DCE - HOTEL STAKEHOLDER FEEDBACK

DCE HOTEL – STAFF ANALYSIS RECOMMENDATIONS

Dav. Commons East - Hotel
Work Session Presentation — Public Feedback
Trey Akers, Planning Dept.
August 22, 2017

DCE HOTEL - PROPOSED PLAN

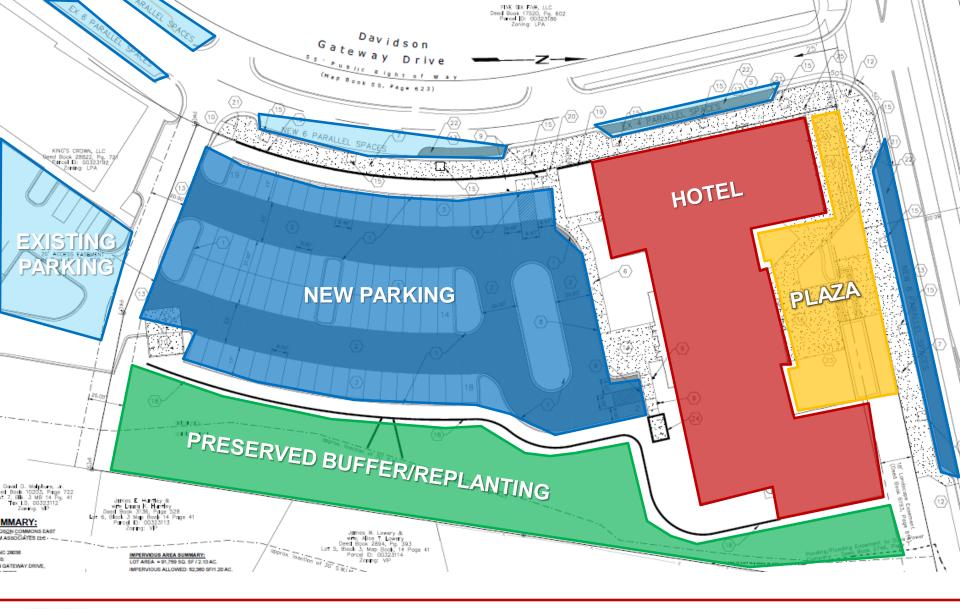
- TIA: Minimal/No Change; Less Impact than Two Commercial Buildings
- Required: 149 Parking Spaces [1.3 Spaces/Room]
- Proposed: 113 Parking Spaces [0.98 Space/Room]
 - Includes Surface, On-street Existing + New, Shared/Woodies
 - Homewood Suites: 84% Capacity on Sold-Out Night

- Required: 3,375 SF [Includes Adjacent Park Discount of 25%]
- Proposed: 7,311 SF Plaza

- Required: 52,360 SF
- Proposed: 52,336 SF

- Existing: Mature Tree Cover/Eastern Border [Woodies Precedent]
- Proposed: Retained/Replanted Eastern Border [1.5x # Removed on Griffith]

- Existing: Stands of Mature Trees, Frame Street
- Proposed: Replace with Formalized Streetscape, Replant Eastern Buffer
 - Tradeoffs: Plaza/Pedestrian Realm, Retail Viability, Parking Capacity,
 Consistency with Existing/Adjacent Properties + New Buildings
